Access Compliance Report

Public Rights-of-Way

Intersection ID: 42643	Main Street: E_3RD_ST	Cross Street: E_JOHN_BELK_RA	Location: NW
ADA ID: 8B1748DB2E58	Ramp Type: Directional1	Initial Pass/Fail: Fail	Overall Compliance: No
		Severity Score: 1.25

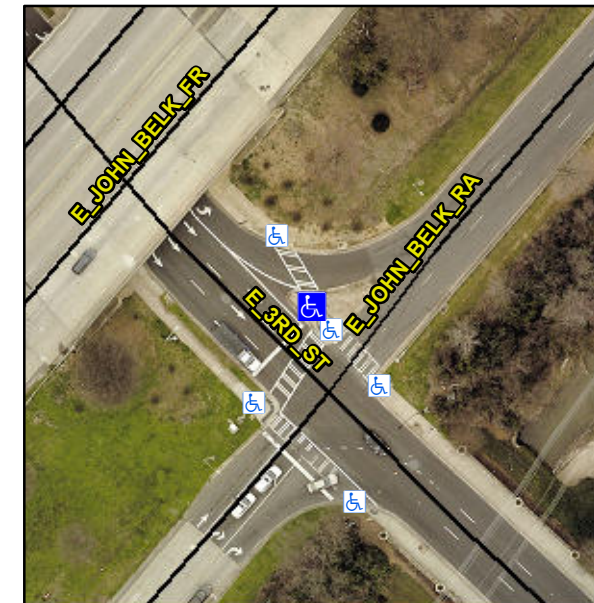
LOCATED ON ISLAND

R304.5.3

Remove & Replace Entire Ramp.
